**ADDENDUM NO. 3**

**SPLASH PAD RENOVATIONS**  
**(3% MBE PARTICIPATION GOAL)**

**June 2, 2026**

**NRC  
 C-154**

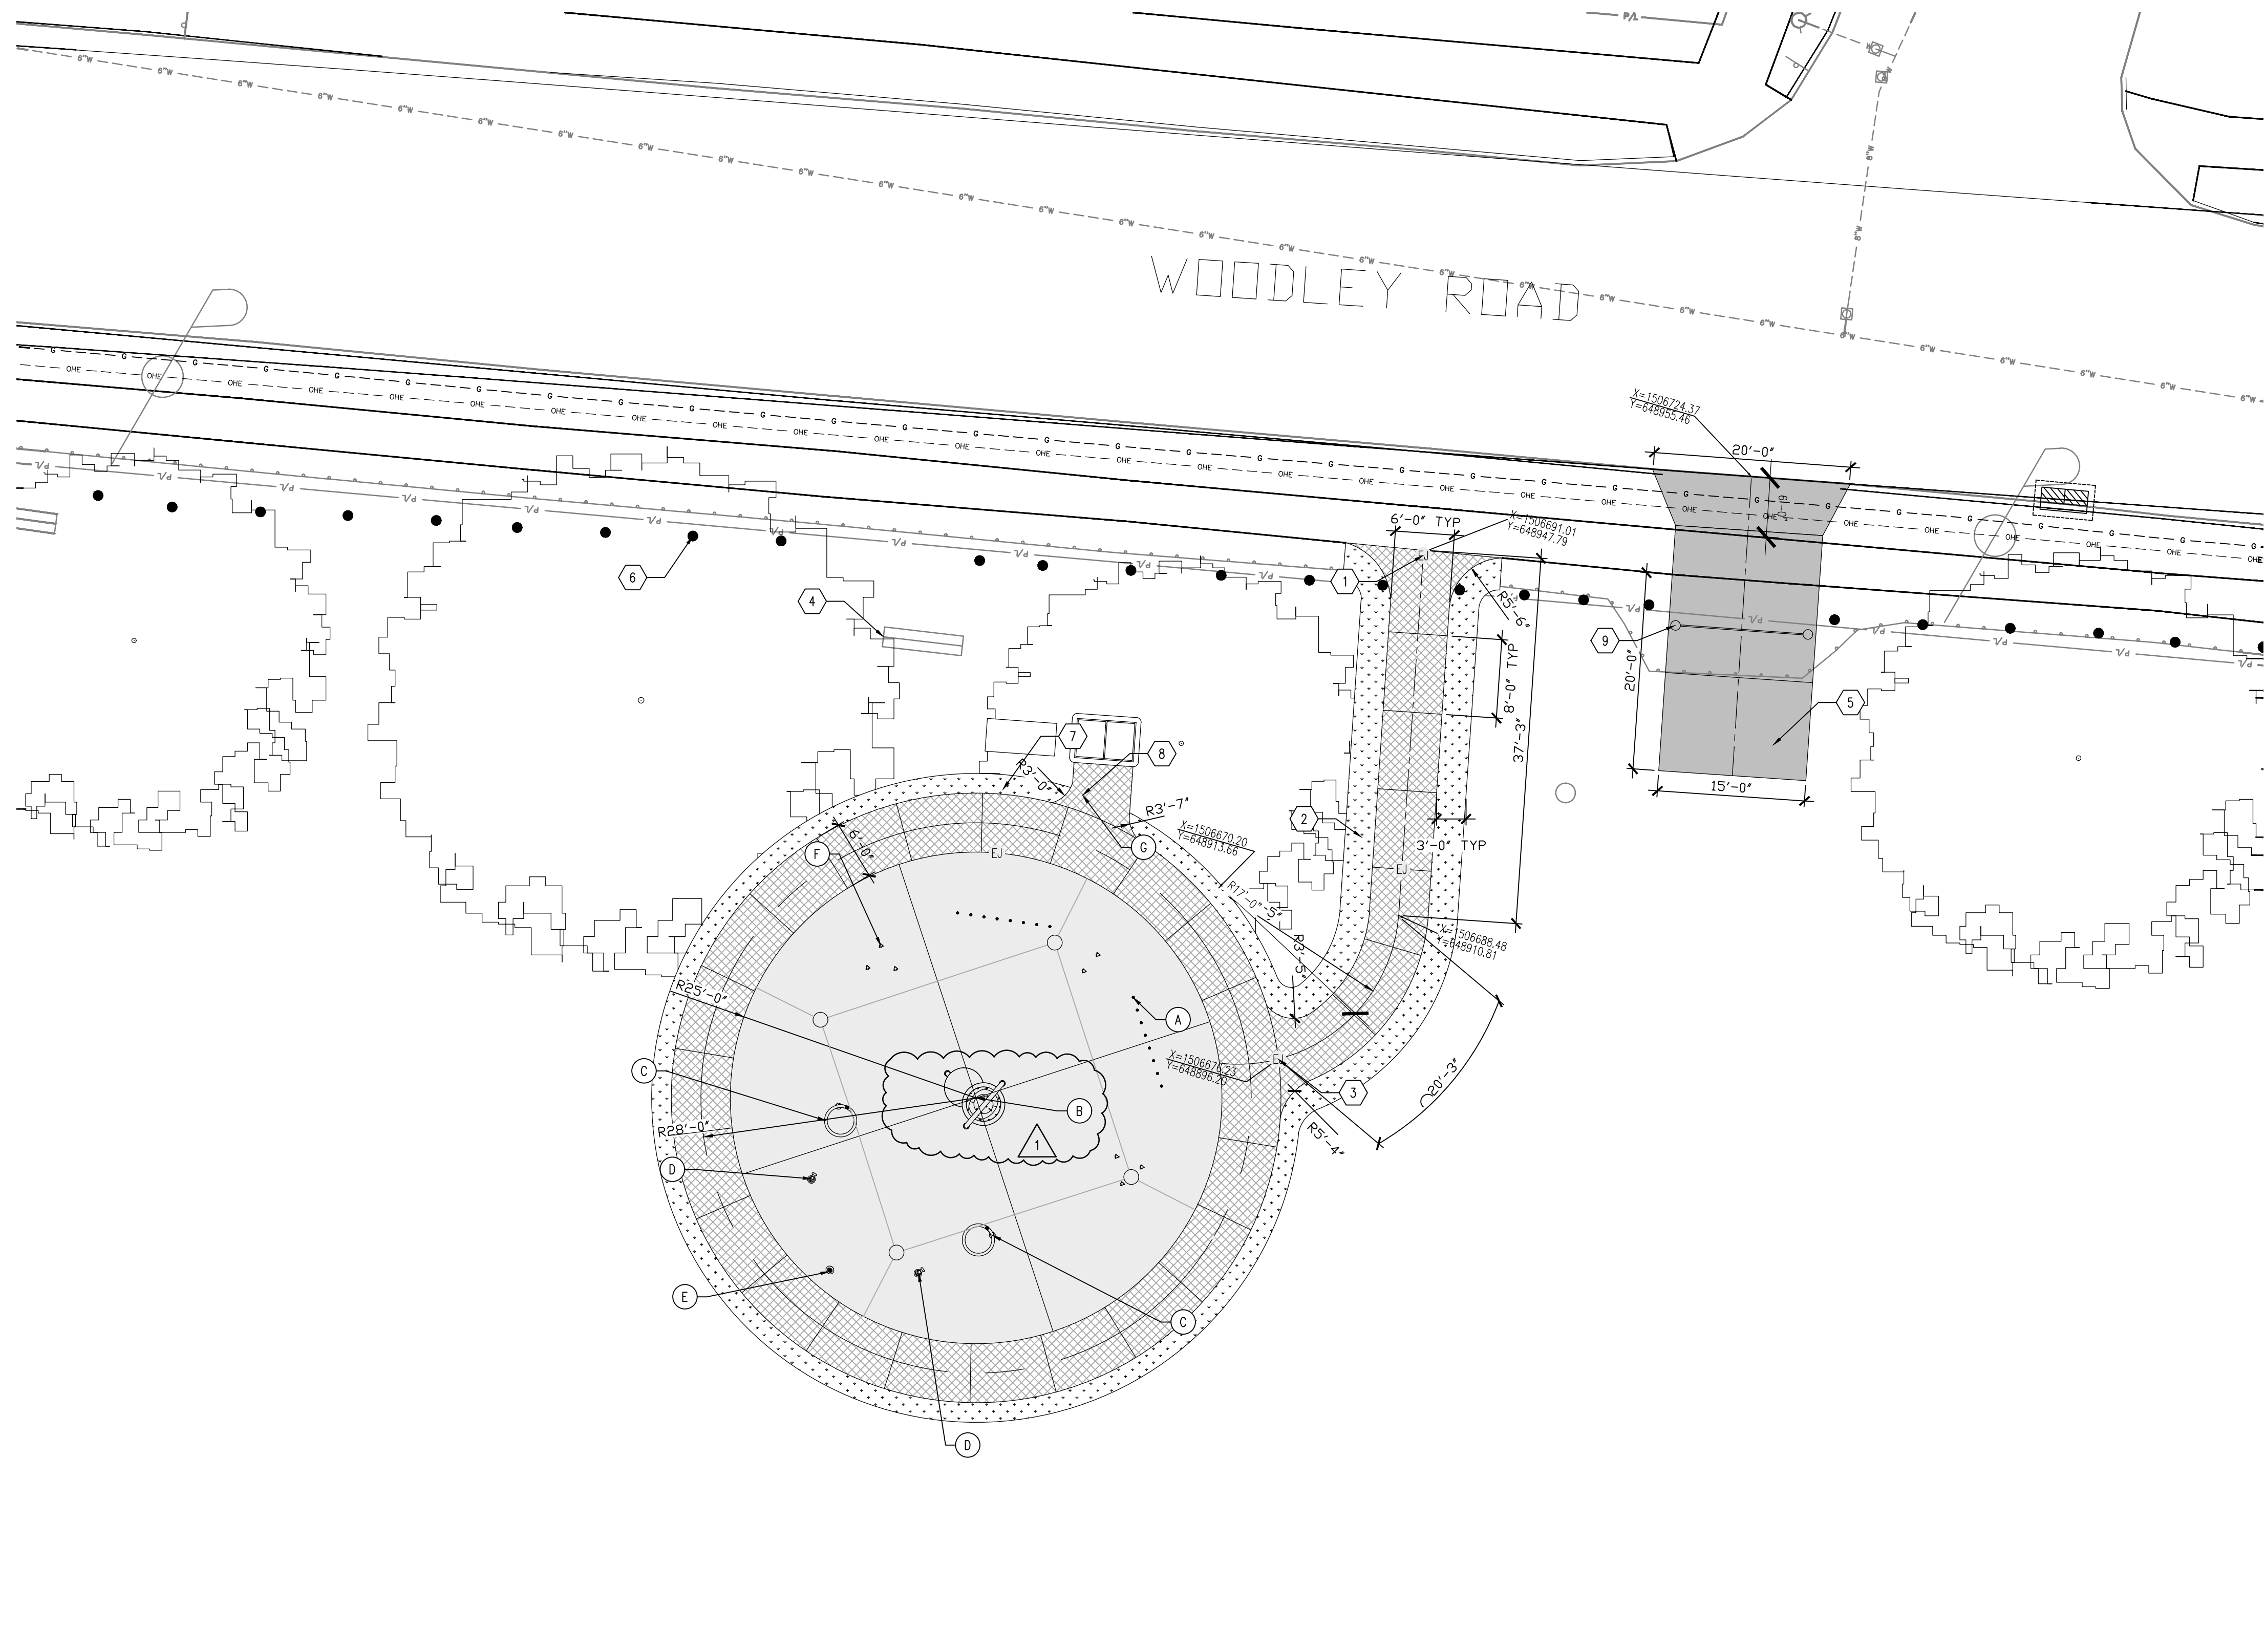
Northwest: Waterplay confirmed that the four “Surf Stone” features can operate from a single supply line. Two water lines have been removed, and the remaining “Surf Stone” water line has been rerouted to the “Mr. Rabbit” feature to accommodate the higher GPM demand.

WP  
C-182

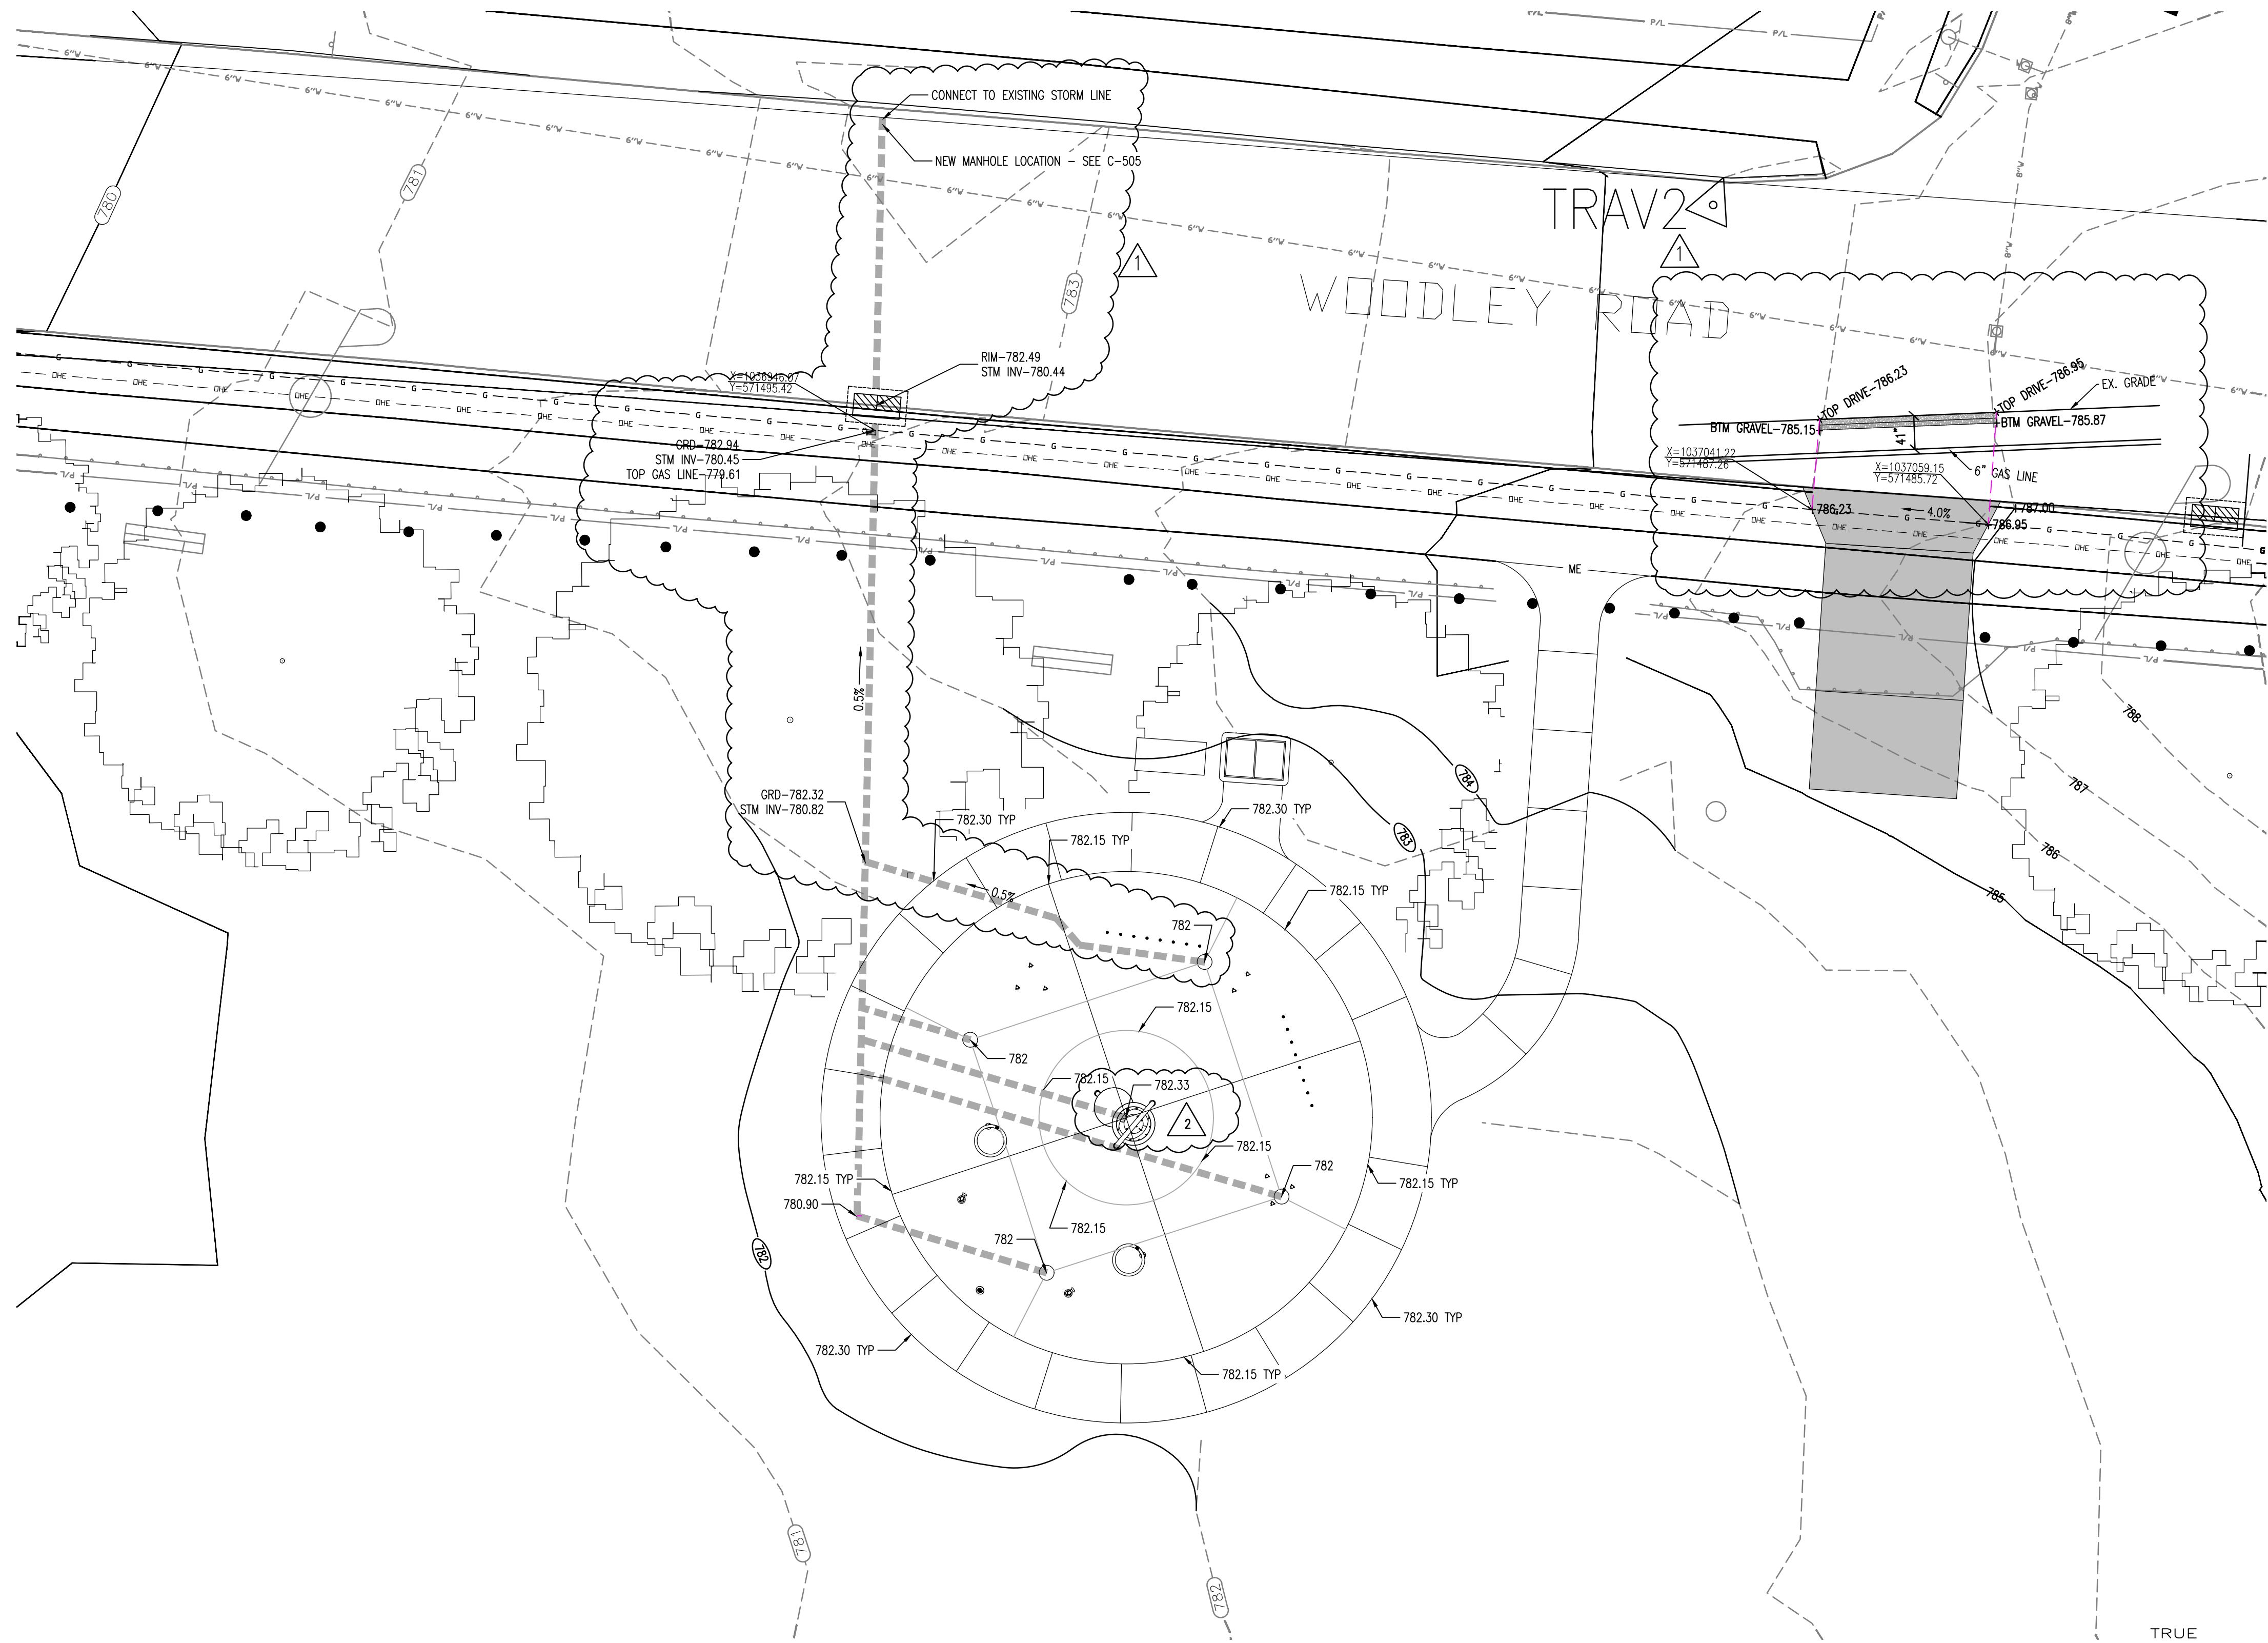
Washington: Waterplay recommended relocated the “Mega Soaker” to the center of the splash pad due to its splash radius. To accommodate this:

- The center drain has been removed.
- Grading has been revised to direct flow to the four surrounding drains.
- The associated piping has been adjusted.
